#### **DOCKET NO. 52002**

## APPLICANT'S RESPONSE TO COMMISSION STAFF'S FIFTH REQUEST FOR INFORMATION TO CPR WATER SUPPLY COMPANY, LLC QUESTION NO. STAFF 5-1 THROUGH 5-6

CPR Development - Public Water System ID № 2120112 Proposed Water Plant and Commnity Water System Engineer Contact Telephone: (903) 729-6005 Plan Review Log № P-09222021-134 Smith County, Texas

CPR Development Map.pdf

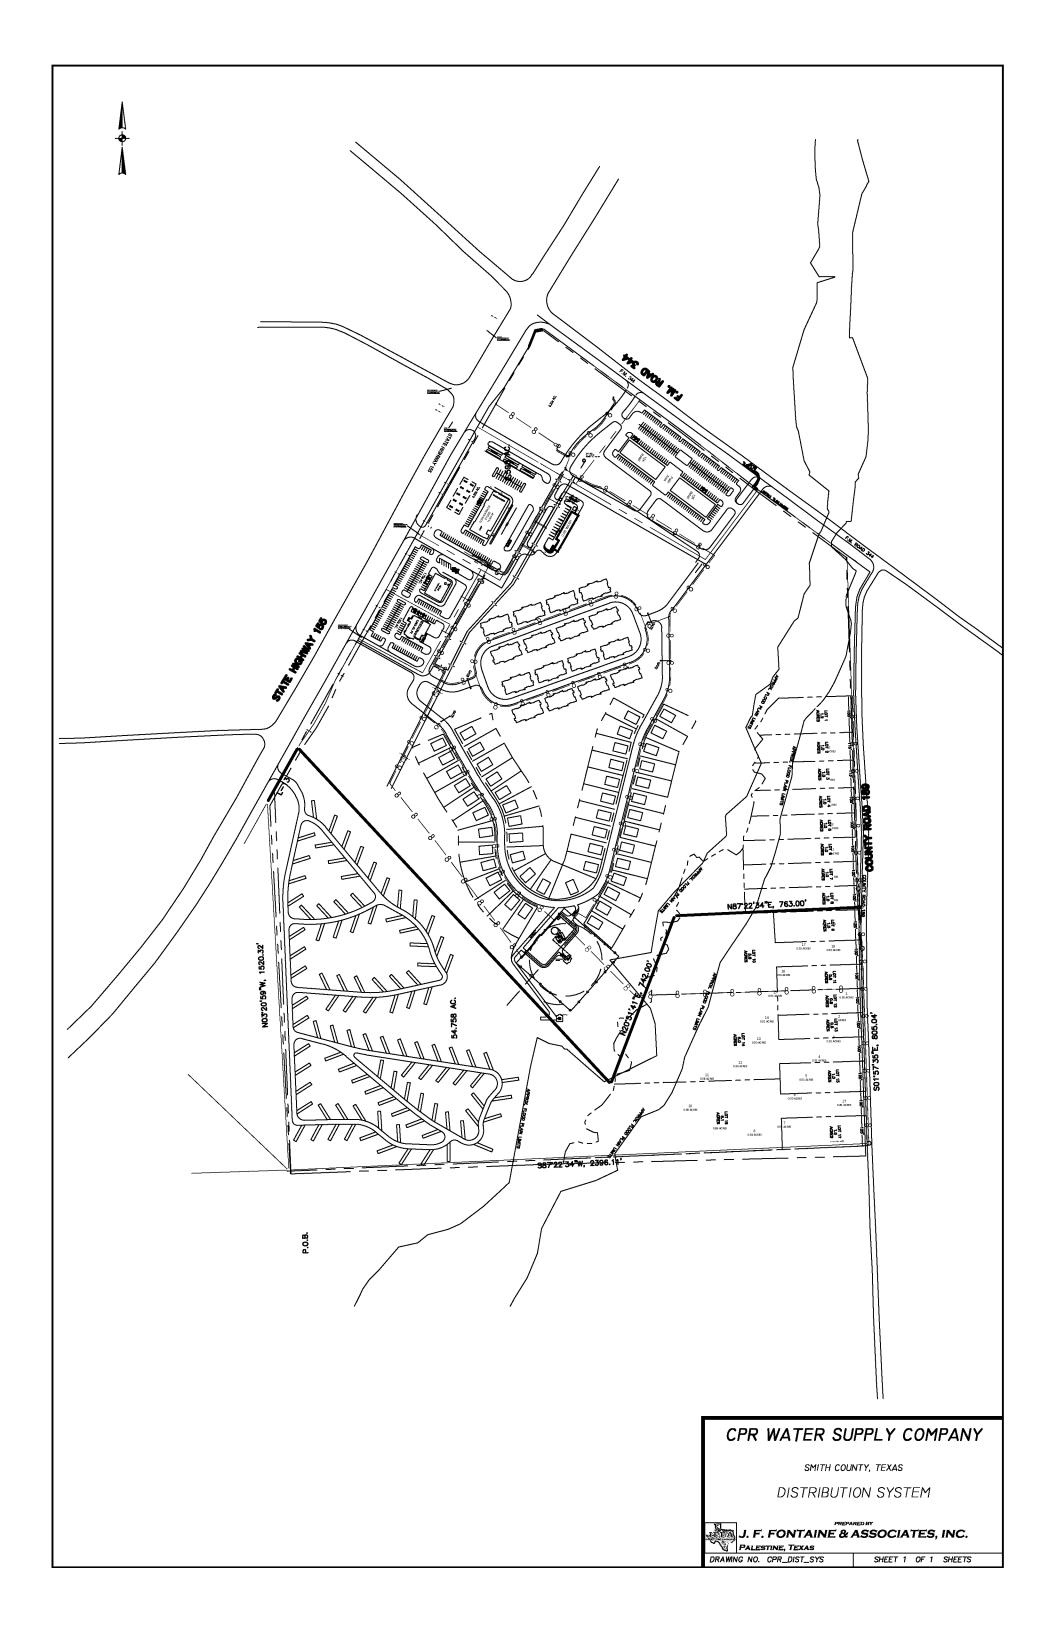
Staff 5-5 Please provide an estimated timeline for construction of all facilities, necessary to provide full service to the requested area, keyed to a map showing where the facilities, distribution system lines, and all the connections will be located.

The estimated timeline for full construction of water production facilities is six months from approval to construct. The estimated total buildout of all 150 connections including all of the water distribution system is projected by the end of the second year of operation. Attached is map showing the proposed complete buildout of the entire requested service area. This map shows the location of the water facilities, all 8" diameter water mains and the proposed location of all connections. The request service area is being developed as a mix use development with commercial business, a recreational vehicle park, manufactured housing lots and lots for residential homes.
